**RE: STAR CIDER – 3365 STATE ROUTE 364
FINAL SUBDIVISION & SITE PLAN REVIEW
TAX MAP NO. 98.11-2-8.000
CPN NO. 013-18
MRB PROJECT NO.: 0300.12001.000 PHASE 134**

MRB has completed a review of the submitted Final Subdivision & Site Plans regarding the above referenced project, dated June 15, 2018, last revised June 22, 2018 prepared by Marks Engineering. We offer the following comments for the Planning Board's consideration. A brief written response to each comment should be provided by the design engineer.

TYPICAL WATER SERVICE

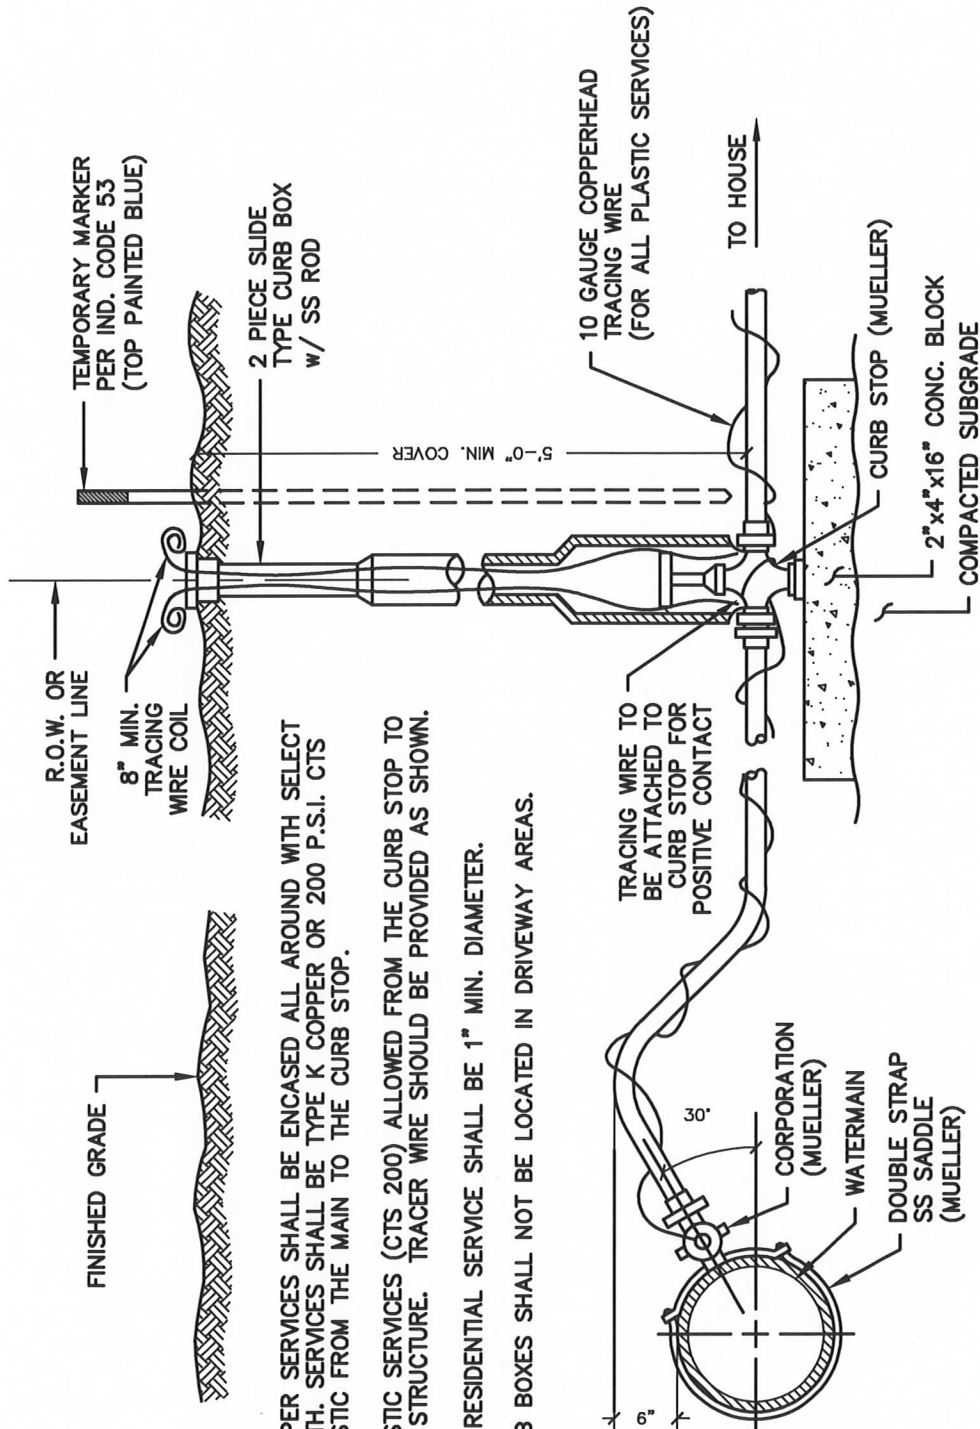
12. The proposed water service materials are to be updated to reflect DR-14. Also calculations for the sizing of the proposed water service should be provided with the next submission.
